GENERAL

This addendum forms a part of the Contract Documents and modifies the original Bidding Documents dated November 2024 and consists of pages AD2-1 through AD2-10 The following changes, additions and/or deletions shall be made to the following documents: all other conditions shall remain the same.

ITEM NO. I – CONTRACT DOCUMENTS
ANNOUNCEMENT TO PREQUALIFIED BIDDERS
SUPPLEMENTARY INSTRUCTIONS TO BIDDERS

PROJECT SITE
DAVIS TOWER (BLD-1445)
1ST FLOOR
2315 STOCKTON BLVD,
SACRAMENTO, CA 95817

RFI #17: Sheet A511A, Phase 1 Demolition Plan - Plan shows FB Wall relocating and additional FSDs being added.
1. Are the walls in Pink (to the Right) full Height?

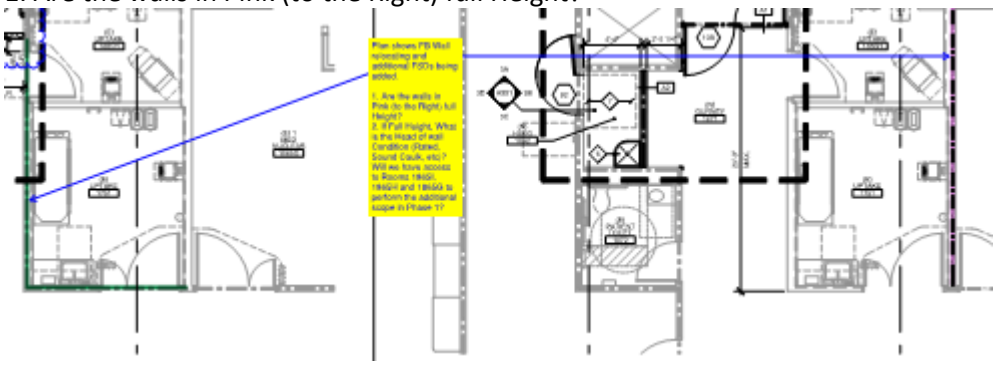
2. If Full Height, What is the Head of wall Condition (Rated, Sound Caulk, etc)? Will we have access to Rooms 1865I, 1865H and 1865G to perform the additional scope in Phase 1?

Response: The walls are full height.

Response: The existing top of wall condition are fire rated. Access to Rooms 1865I, 1865H and 1865G will be available upon schedule coordination with the University.

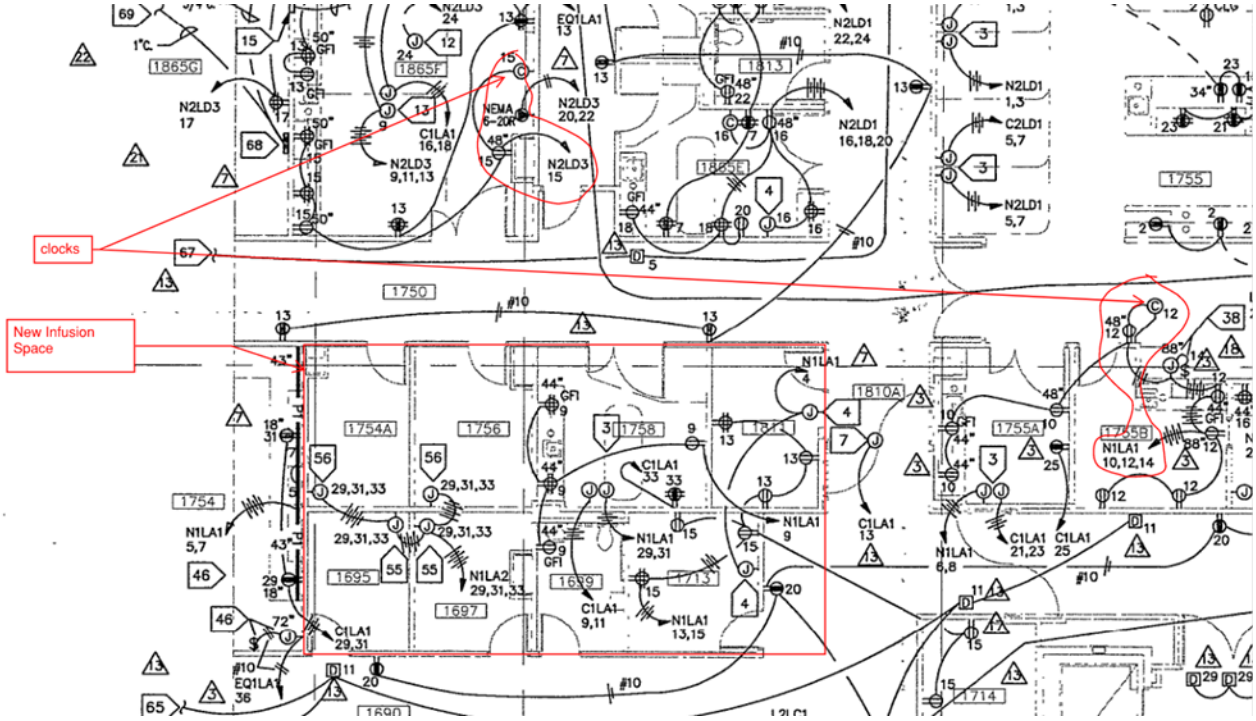
RFI #38: Sheet E512 - There are two new clocks shown on drawing E512 (note 4) tied to circuit N1LA1-9 but specification 27 53 13 item 3.2.A directs us to wire all secondary clocks in parallel. Therefore, we believe these two new clocks need to be connected to an existing clock circuit, such as the existing clock shown on drawing E511B, in order for the master clock to synchronize with the new clocks. Please confirm..
Response: It was observed in the as-builts provided for the Davis Tower that the existing clocks near the new infusion space are connected to different receptacles circuits, not in parallel. No changes to electrical plans for the clocks. See attached snapshot below for confirmation.

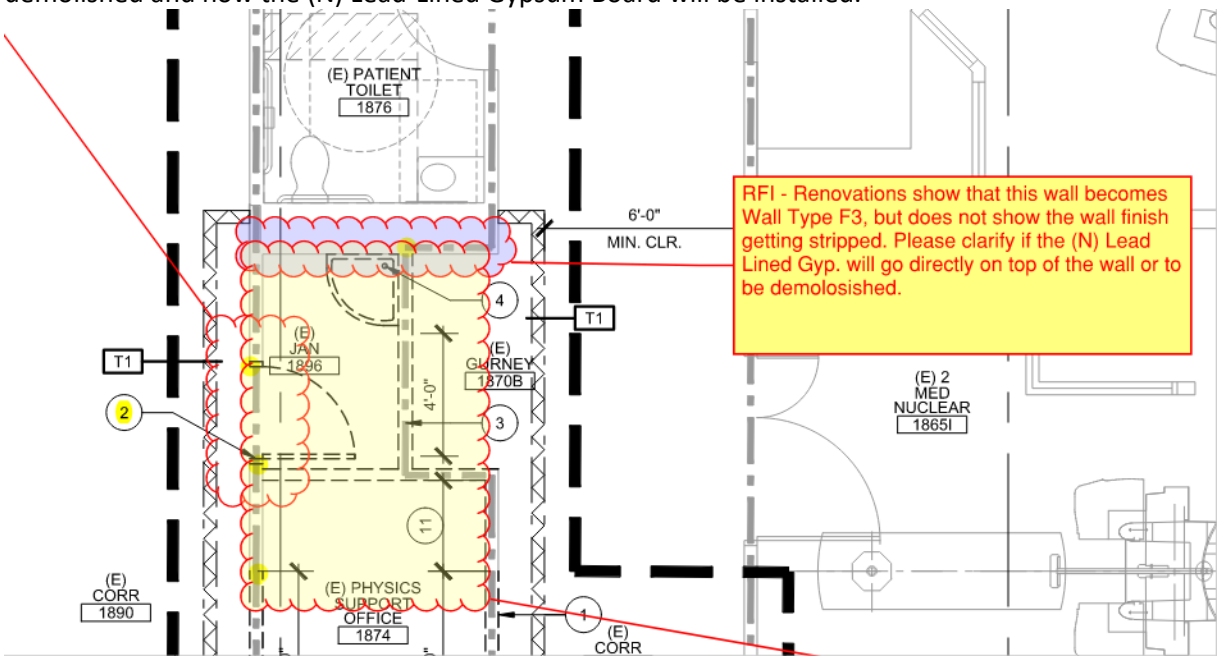
RFI #58: Sheet A511A - The Renovation Plan on Sheet A511A shows (N) Wall Type F3 going up, but does not show the wall and/or gypsum board getting demolished. Please clarify if the wall as highlighted in the image will be

demolished and how the (N) Lead-Lined Gypsum Board will be installed.

Response: F3 is correct. See revised sheet A511A for clarification.

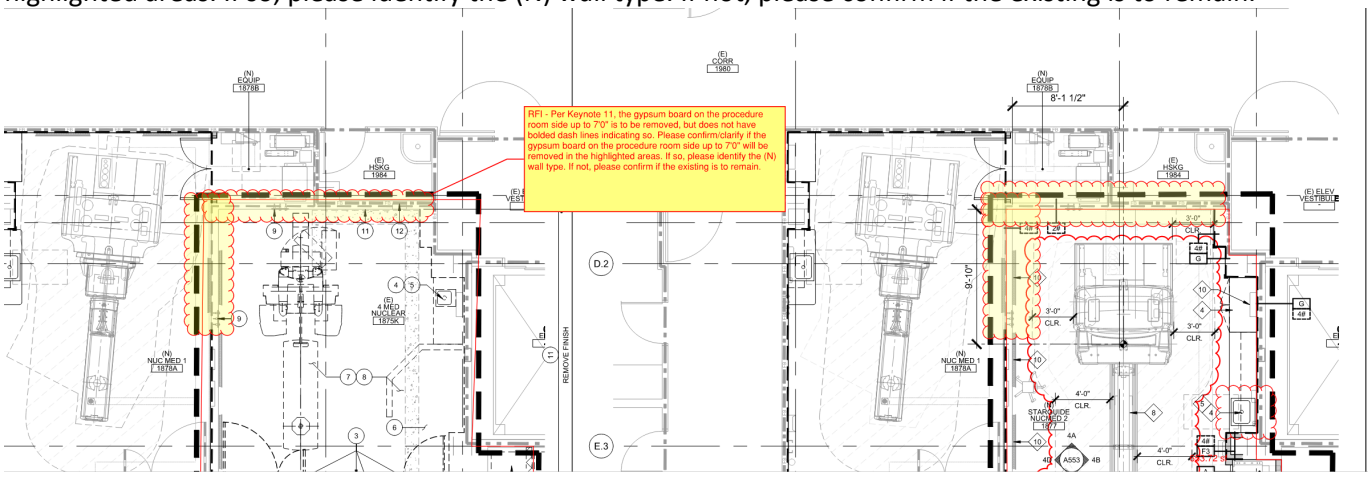
RFI #59: Sheet A511C - In the highlighted areas as shown in the image, per Keynote 11, the '(E) GYPSUM BOARD ON THE PROCEDURE ROOM SIDE UP TO 7'0"'is to be removed, but does not have bolded dash lines indicating such. Please confirm/clarify if the gypsum board on the procedure room side up to 7'0" will be removed in the highlighted areas. If so, please identify the (N) wall type. If not, please confirm if the existing is to remain.

Response: See revised sheet A511C for clarification.

AREA A - PHASE 1 DEMOLITION

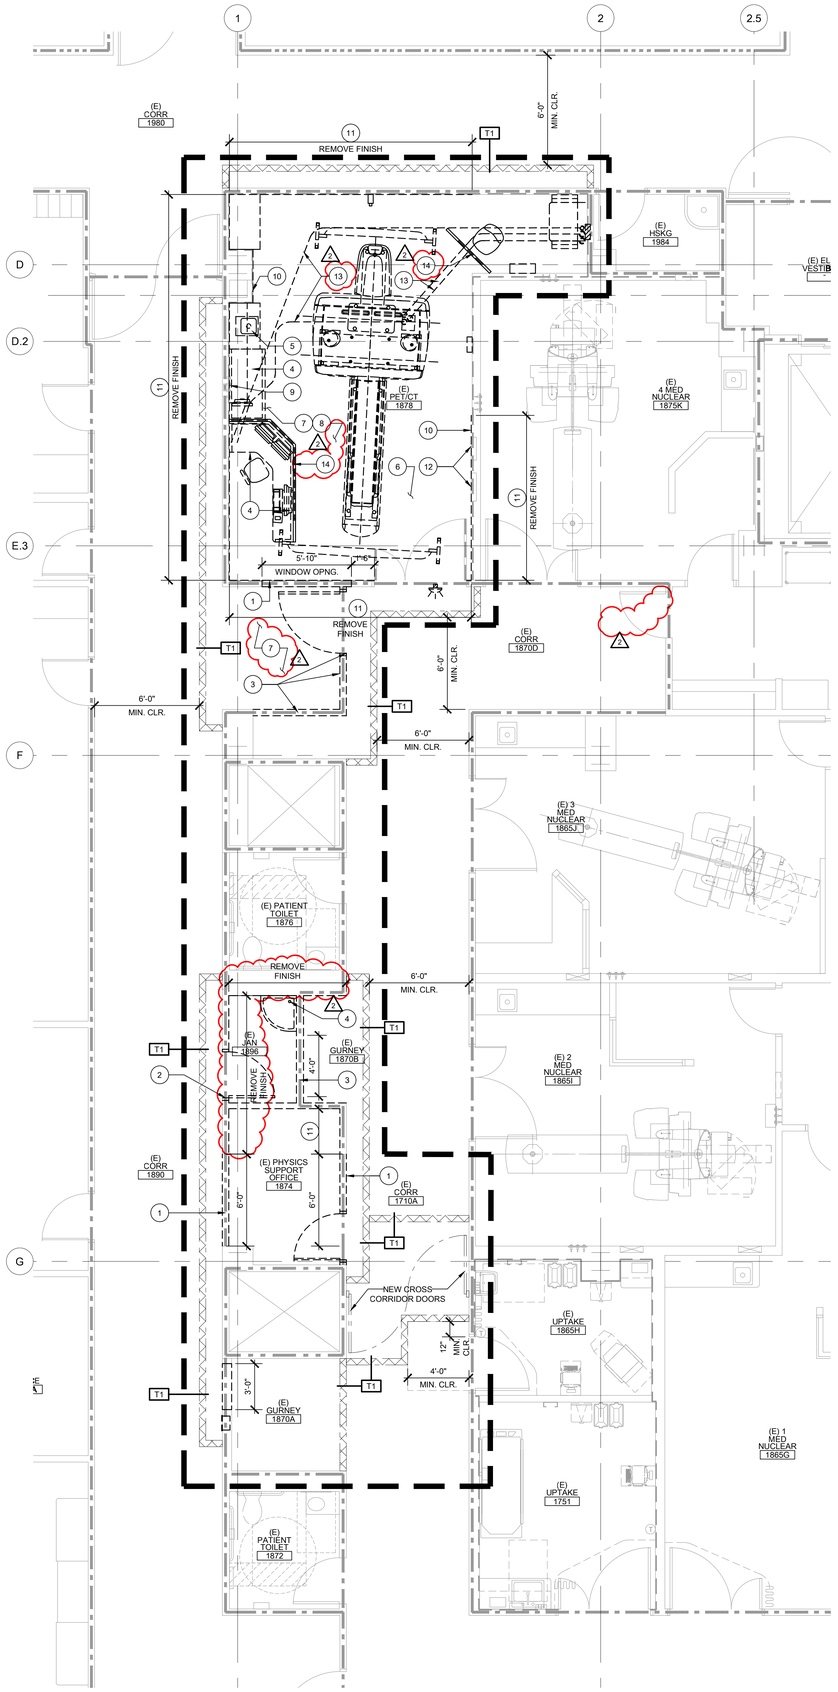
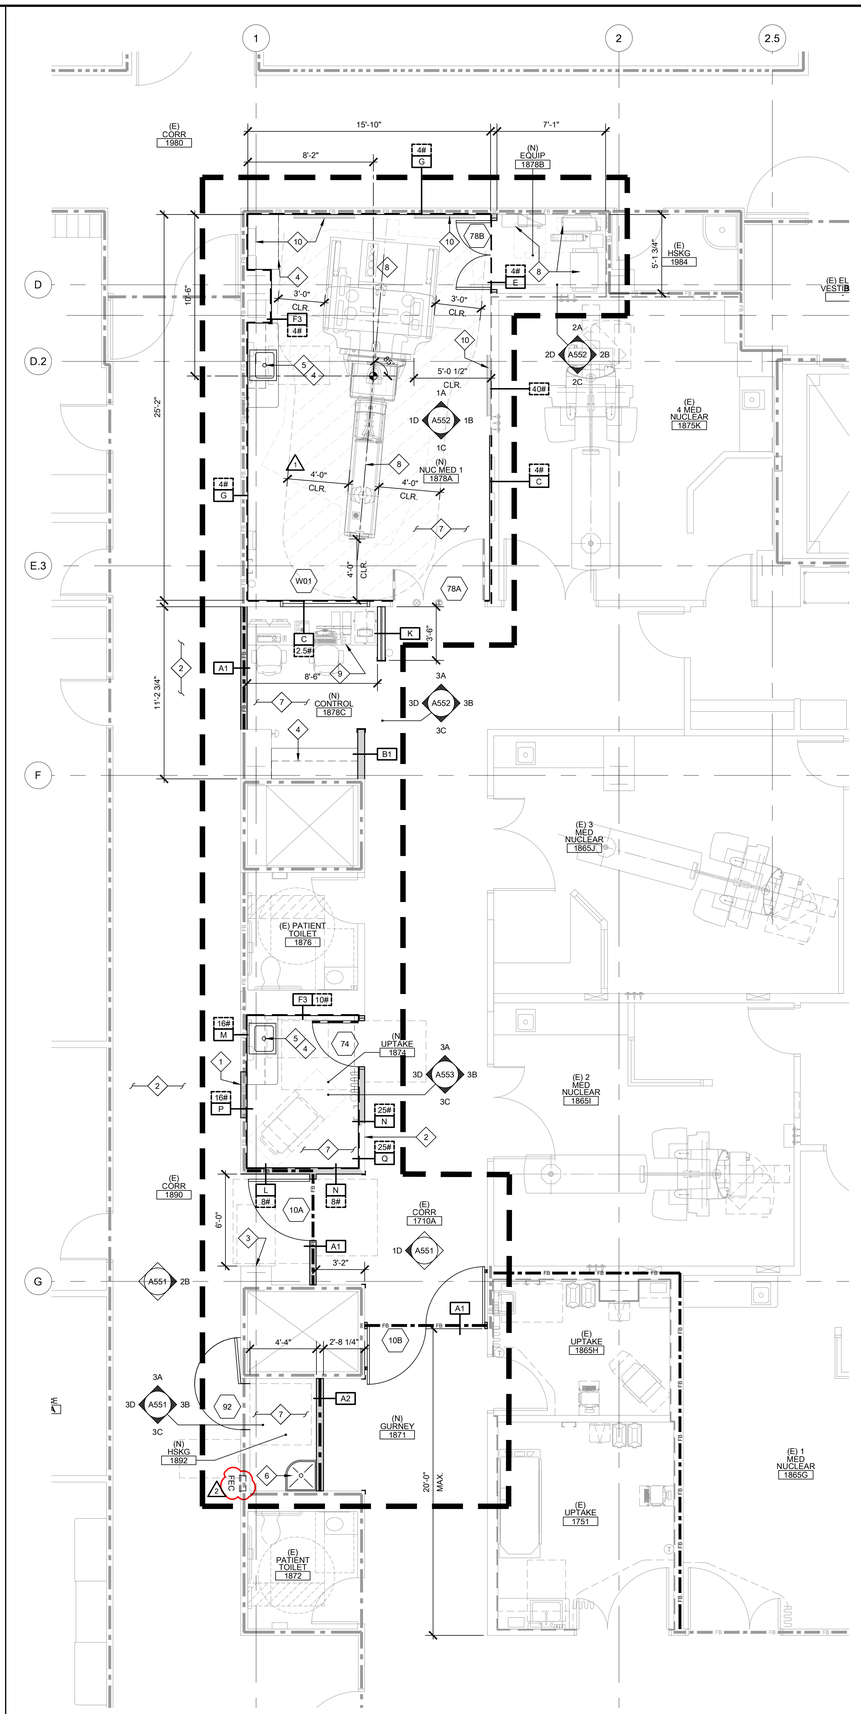
RFI #1: Specification Section 13281 - Please provide haz mat report for us to abate the lead and other Haz mat material. Spec 13281 implies bids to hire survey. How do we know what is Hazardous material and to what extent?
Response: Demolition Plans have been revised to indicate known hazardous material locations and extents. See revised sheets A511A, A511B and A511C.

RFI #15: Sheet A511A, Phase 1 Demolition Plan - Is this note correct for these conduits?
Response: Note 13 is correct for Room 1878. Note 6 and trenching has been removed, see revised sheets A511A, S201 and E311A.

RFI #28: Demolition Keynote 1/A511A calls to "DEMOLISH PORTION OF (E) WALL FOR NEW OPENING," but points to a location outside of the work area. Please clarify.
Response: Assuming that referenced Keynote 1 is at door in (E) CORR 1870D, it has been removed. See revised sheet A511A.

RFI #44: Sheet A511A - Renovation Keynote 7 on Sheet A511A states that Room 1878C is to have (N) Flooring and Base, however the Demolition Plan does not call for that Room 1878C's flooring to be demolished. Please confirm that the (E) flooring and base in Room 1878C is to be demolished..
Response: Yes, the (E) flooring and base in Room 1878C is to be demolished. See revised sheet A511A.

2 AREA A - PHASE 2 DEMOLITION

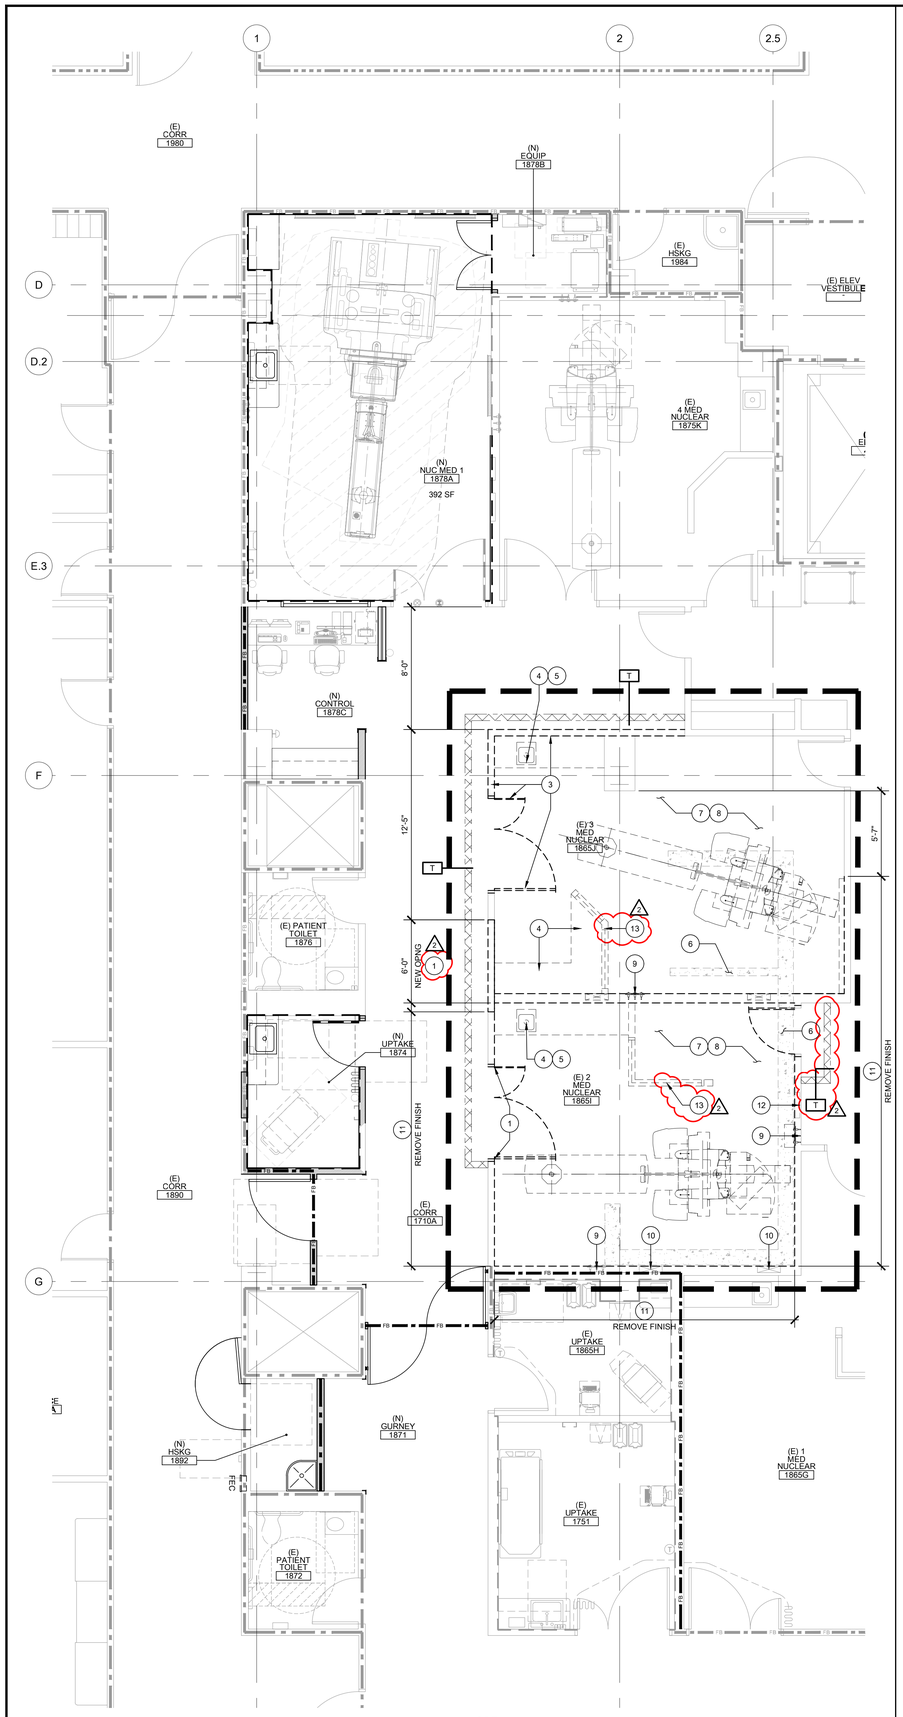
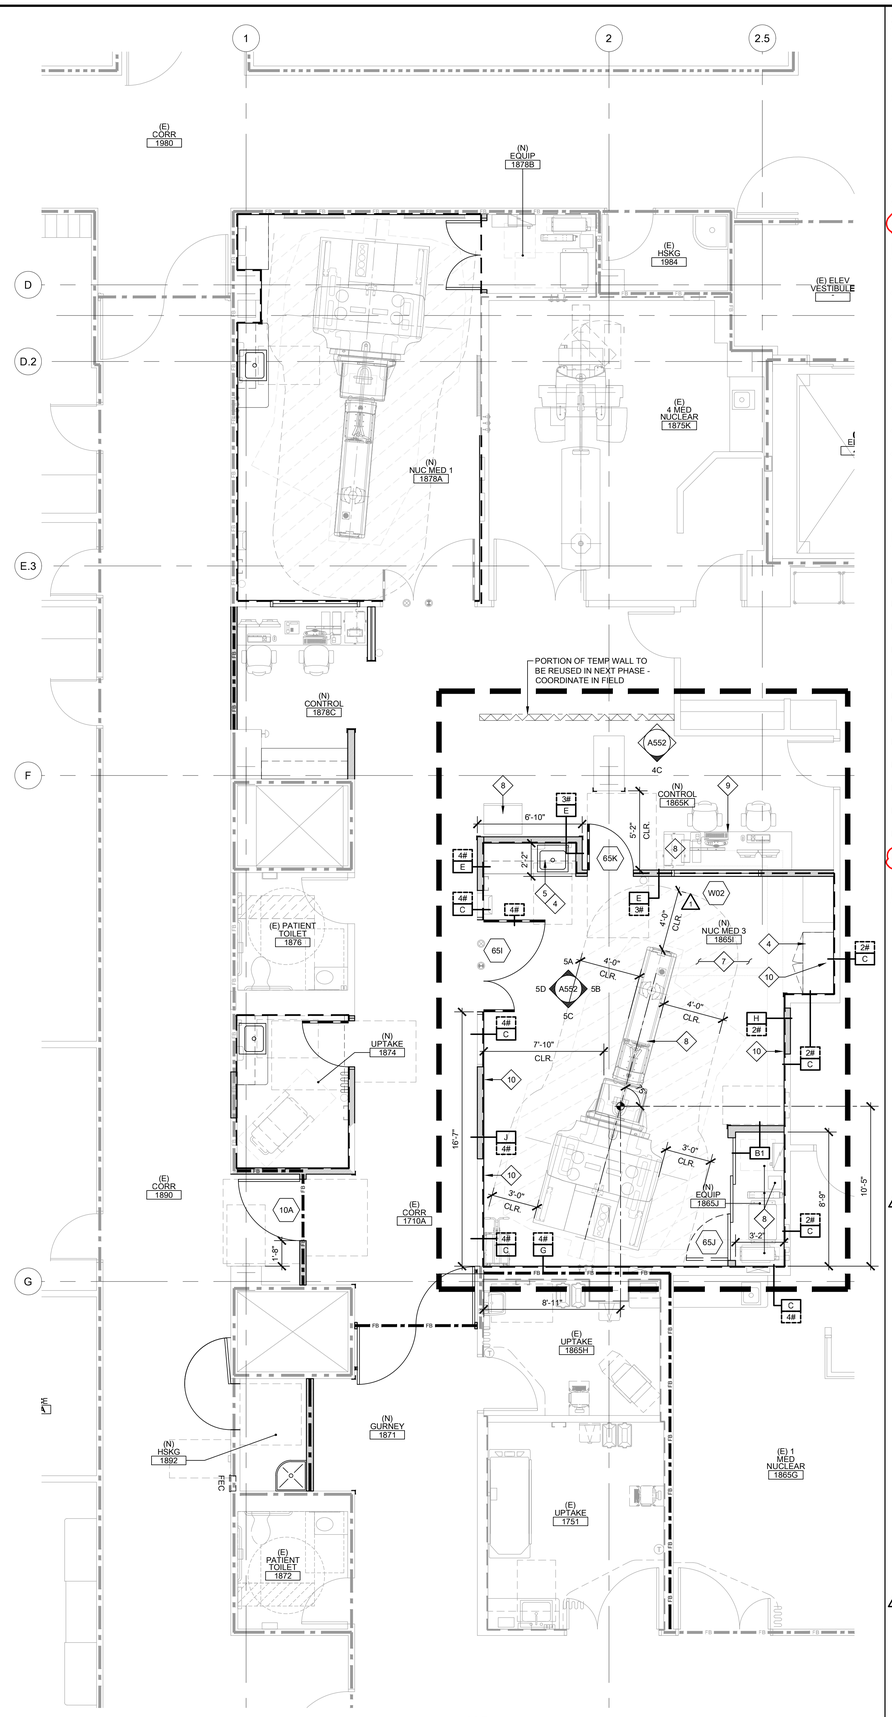
RFI #25: Demolition Keynote 2/A511B calls for areas "NOT USED", however "NEW OPENING" is directly above Keynote 2 on the Demolition Plan. Please confirm if this is a New Opening for a Door as suggested on the Renovation Plans.
Response: Keynote 2 is changed to Keynote 1. See revised sheet A511B

RFI #48: Sheet A511B - Detail 2 Demolition, shows temp walls to the West & North of Rooms 1865J and 1865I. Please confirm that Temp Walls will be needed at the east side where the existing door opening is to be removed and infilled.
Response: Yes, temporary barrier will be required. See revised sheet A511B.
